AES-O-NRC-09-00017-0

AREVA Enrichment Services LLC
Eagle Rock Enrichment Facility
NRC Docket No: 70-7015

Subject: Supplement to Eagle Rock Enrichment Facility License Application - Depth to Groundwater Measurements from the Monitoring Wells on the Site for the Proposed Eagle Rock Enrichment Facility.

Figure 3.4-13 Site Groundwater Potentiometric Surface Map
EAGLE ROCK ENRICHMENT FACILITY ENVIRONMENTAL REPORT

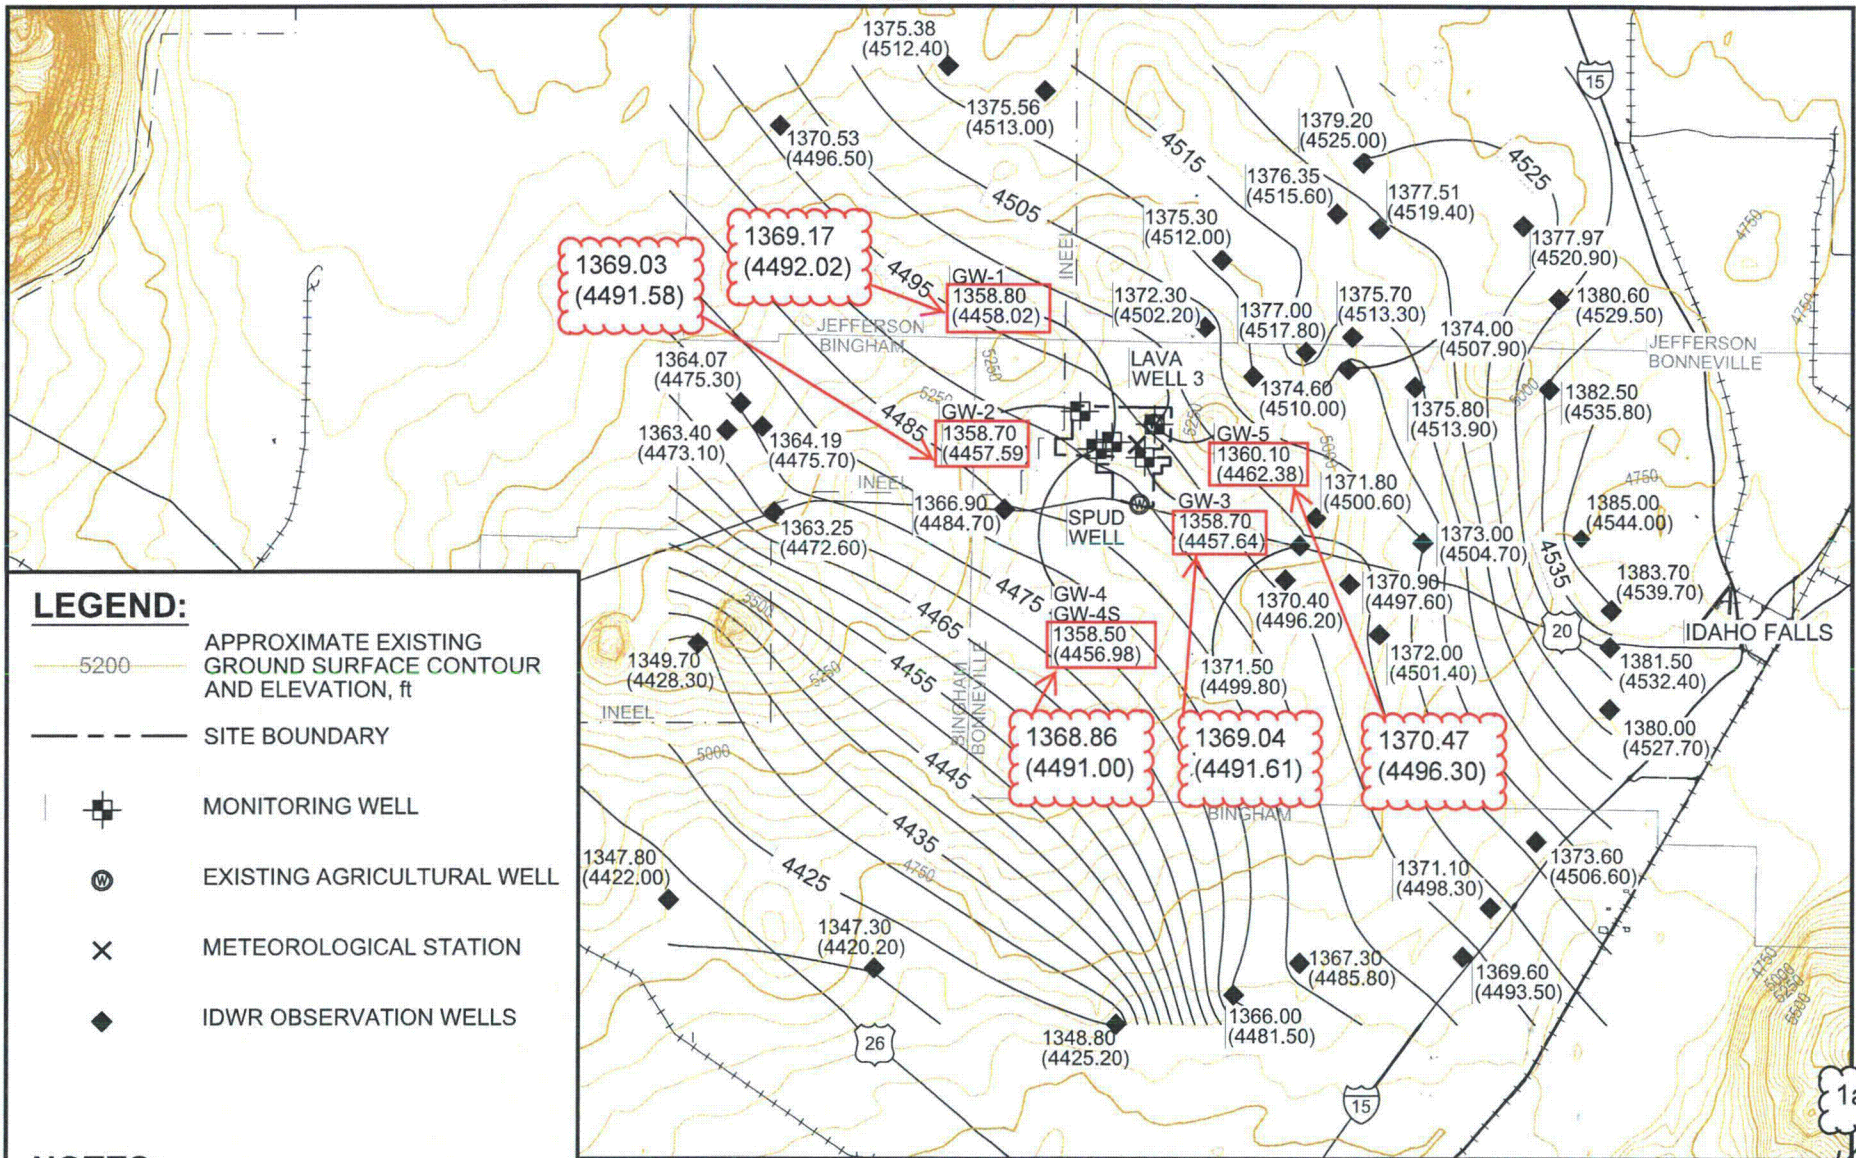
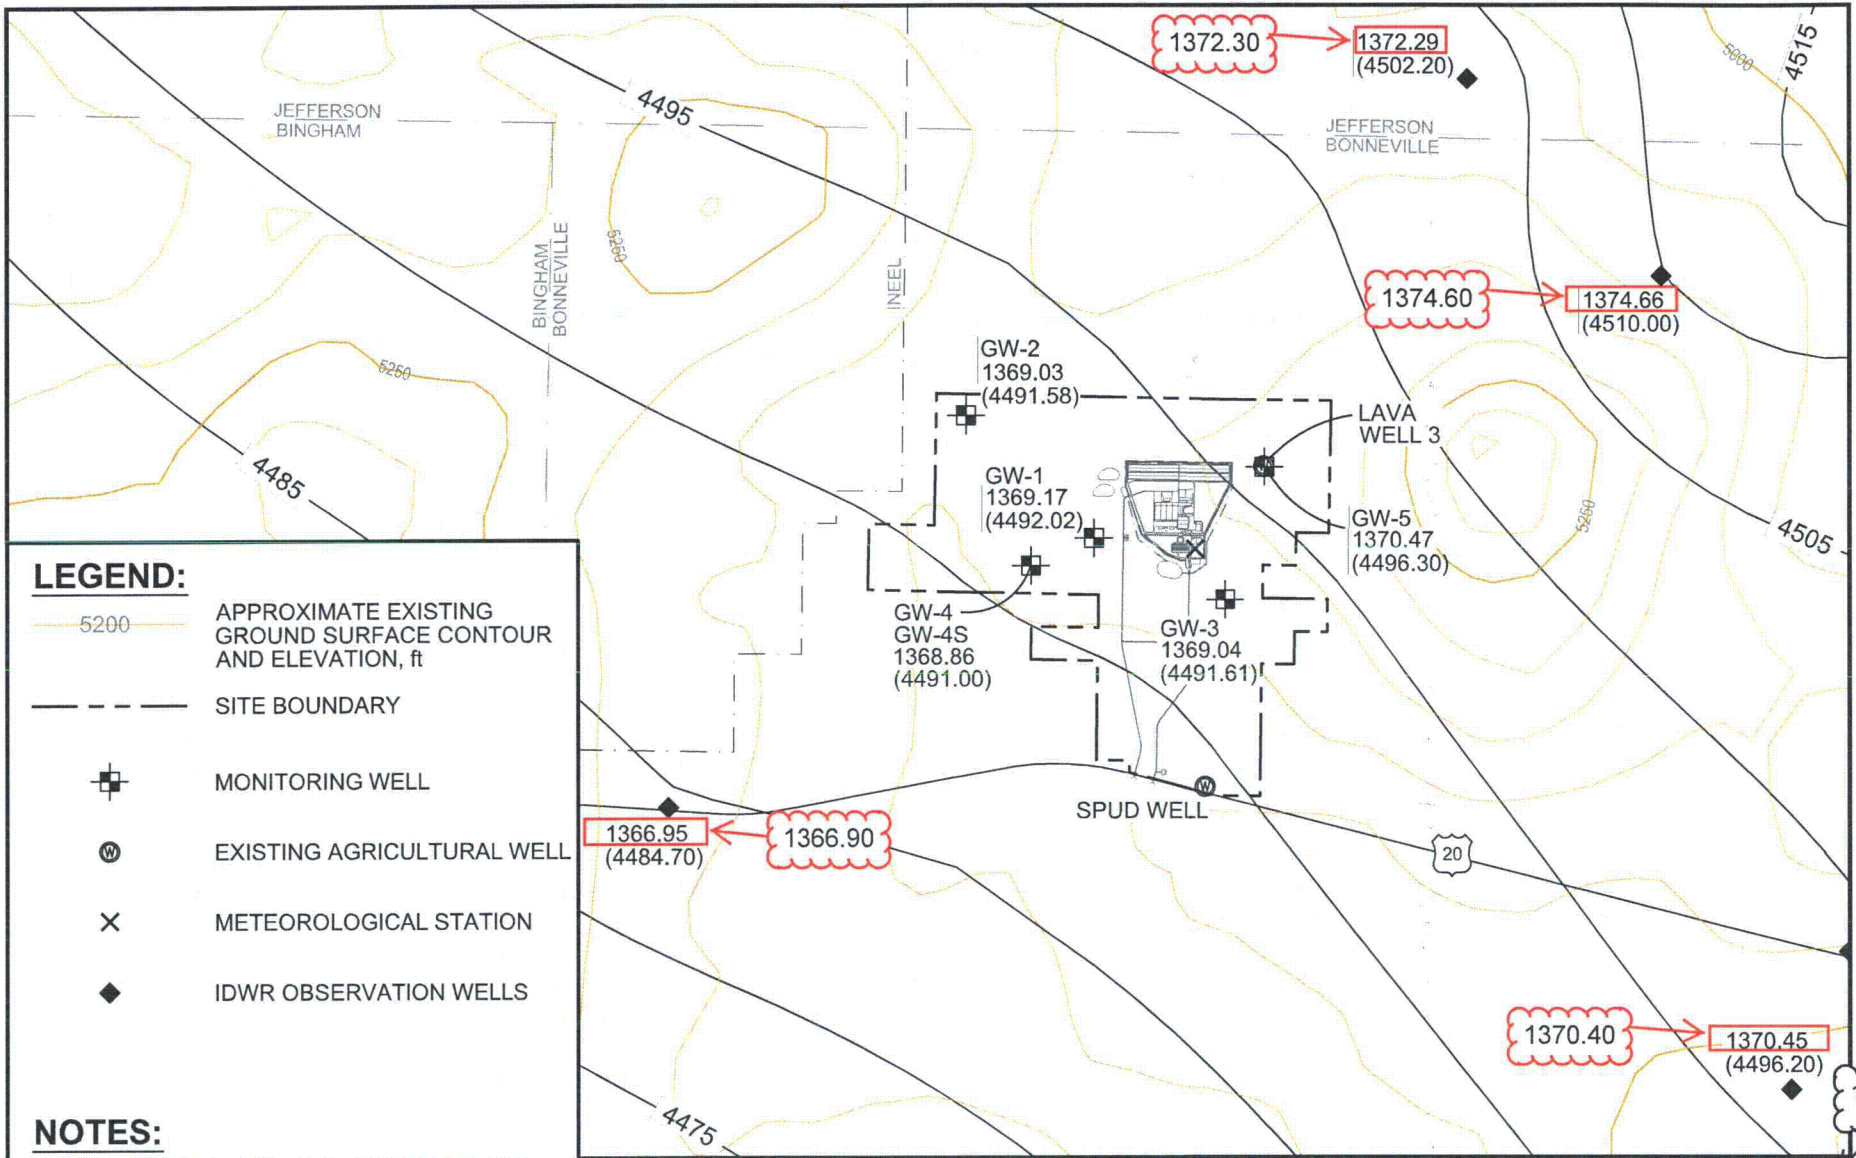
This supplement also corrects information presented in ER Table 3.4-13, Chemical Analyses for the EREF Site Groundwater, page 1 of 9, Revision 1, ER Figure 3.4-12, Regional Groundwater Potentiometric Surface Map, Revision 1, and ER Figure 3.4-13, Site Groundwater Potentiometric Surface Map, Revision 1. For ER Table 3.4-13, the depth to water measurements presented for monitoring wells GW-1, GW-2, GW-3, GW-4, and GW-5 are shown as below ground surface (bgs) measurements; however, these measurements are actually the depth to groundwater from the top of the PVC well casings. Since the PVC well casings extend above ground surface, the length that the PVC well casing is above ground surface (for each well) should have been subtracted from the measured depths to determine the below ground surface (bgs) water depths. For ER Figure 3.4-12, the groundwater elevations presented for monitoring wells GW-1, GW-2, GW-3, GW-4, and GW-5, are incorrect. The elevations presented should have been the same as those presented in ER Figure 3.4-13. For ER Figure 3.4-13, the elevations in meters for the IDWR Observation Wells shown on ER Figure 3.4-13, Revision 1, differ from the elevations in meters shown for the same locations on ER Figure 3.4-12 due to differences in rounding. The elevations in meters for the IDWR Observation Wells shown on ER Figure 3.4-13, are updated to match the elevations in meters shown for the same locations on ER Figure 3.4-12, Revision 1.
